# Service Bulletin

**SUBJECT:** Service Update for Inventory and Customer Vehicles  
Front Bumper Fascia Air Deflector Replacement  
Expires with Base Warranty

**MODELS:** 2013 Chevrolet Malibu  
Equipped with Active Grille Shutters (VRI) and Located in Alabama,  
Arkansas, Arizona, Florida, Georgia, Louisiana, Mississippi, New Mexico,  
Oklahoma, South Carolina, Texas, and Israel

Subject: 13376 – Service Update Bulletin  
Front Bumper Fascia Air Deflector Replacement

2717668

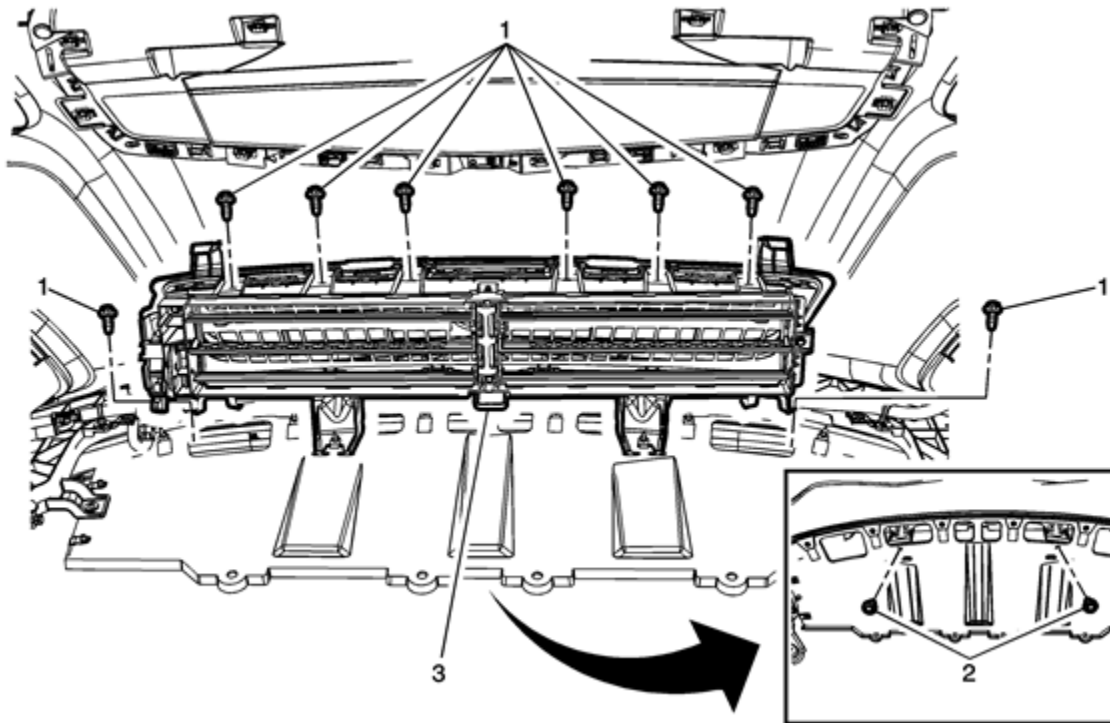
1. Remove the front bumper fascia air deflector from the vehicle. Refer to *Front Bumper Fascia Air Deflector* in SI.
2. Install a new front bumper fascia air deflector. Refer to *Front Bumper Fascia Air Deflector* in SI.
